Access Compliance Report

Public Rights-of-Way

Intersection ID: 31970	Main Street: BERNBROOKE CT	Cross Street: THORNTON OAKS CT	Location: SW
ADA ID: 50B572CB3B50	Ramp Type: PerpDiag	Initial Pass/Fail: Fail	Overall Compliance: No
Codes/Mitigation Info/Possible Solution			Severity Score: 10
			Field Measurements/Component Compliance

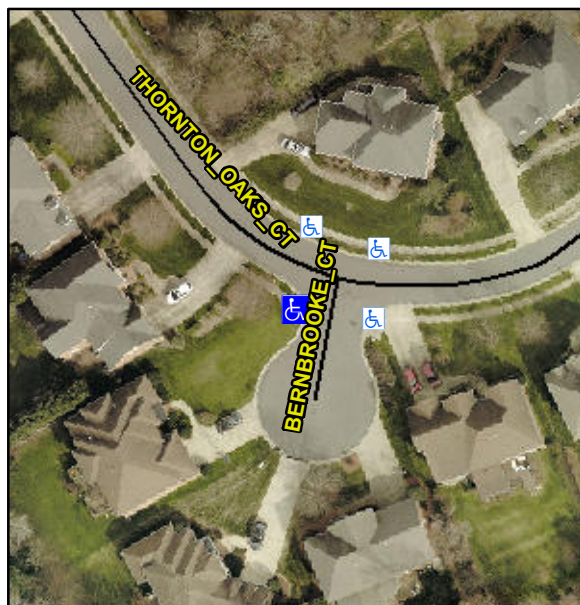
Not Found, R304.5.1, R304.5.3

Compliance	Description	Data	Compliance	Description	Data
N/A	Ramp Length (in)	43.0	Yes	Ramp Slope (%)	6.2
No	Ramp Width (in)	41.0	No	Ramp XSlope (%)	3.9
N/A	Flare Type LT	N/A	N/A	Flare Type RT	N/A
N/A	Flare Slope LT (%)	N/A	N/A	Flare Slope RT (%)	N/A
N/A	Flare Traversable LT?	N/A	N/A	Flare Traversable RT?	N/A
N/A	Landing Length (in)	N/A	N/A	DWS Provided?	N/A
N/A	Landing Width (in)	N/A	N/A	DWS Contrast?	N/A
N/A	Landing Slope (%)	N/A	N/A	DWS Length (in)	N/A
N/A	Landing X Slope (%)	N/A	N/A	DWS Full Width?	N/A
N/A	Landing Curb? (Y/N)	N/A	N/A	DWS Offset (in)	N/A
N/A	Shared Landing?	N/A			
N/A	Gutter Ponding?	N/A	N/A	Gutter Slope (%)	N/A
N/A	Gutter Lip Ht (in)	N/A	N/A	Gutter X Slope (%)	N/A
N/A	Painted X Walk1?	No	N/A	Painted X Walk2?	No
	X Walk 1 Direction	To E		X Walk 2 Direction	To N
N/A	X Walk 1 Width (in)	N/A	N/A	X Walk 2 Width (in)	N/A
	X Walk 1 Slope (%)	1.7		X Walk 2 Slope (%)	2.4
	X Walk 1 X Slope (%)	1.4		X Walk 2 X Slope (%)	0.3

Remove & Replace Curb Ramp With Two New Directional Ramps or Equivalent.
